CAPISTRANO BAY DISTRICT
AGENDA REPORT
October 25, 2016

Continued Discussion of New Trash Enclosure at 35587

Trash Enclosure - 35587 - Steve Reid

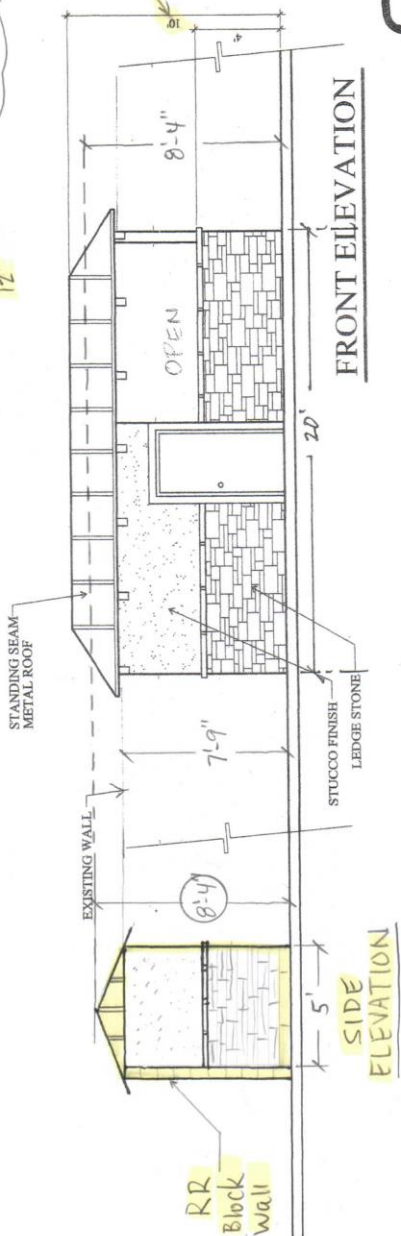
This item requires further discussion regarding the allowable height of Mr. Reid's proposed trash enclosure. The Board is undecided on whether the height of the structure should be no greater than the height of the existing RR block wall OR if it could exceed the block wall height by about 6 inches.

These enclosed trash structures that are built up against the existing RR block wall, and have roofs, must be able to drain rainwater in such a manner so that it doesn't get trapped against the back wall. This essentially requires the roof to sit at least at the height of the wall unless the design is such that the entire roof sheds water AWAY from the block wall.

In most of the recently approved trash enclosures, the RR block wall is between 5'-7" to 6' high. In the case here at 587, the wall is 8'-4" in height – a good 24" higher than the others.

The issue is not with the proposed design but with how the proposed height will appear to be too high and visually imposing. While the Board is cognizant of the homeowners' needs to create additional storage, there is also a concern with allowing these structures to grow to excessive size.

REVISION lower roof to 8'-4"

* Note: lower roof to 8'-4" 10' is too high

I thought the board's preference was to drain on the railroad side of the wall? This makes the most sense to me and is what most others have done. Unless I can reduce a course or two from the wall there is not much I can do.

Several trash enclosures are +/- 7' with walls lower. As I said when we met I really am not a fan of the shed roofs that several owners have done as they are not nearly as attractive, at least in my opinion. I am not sure if it would help but we could change to a gable roof. I wanted it to be as attractive a structure as I could design it so it has some interest as opposed to just a big box that looks like a shed.
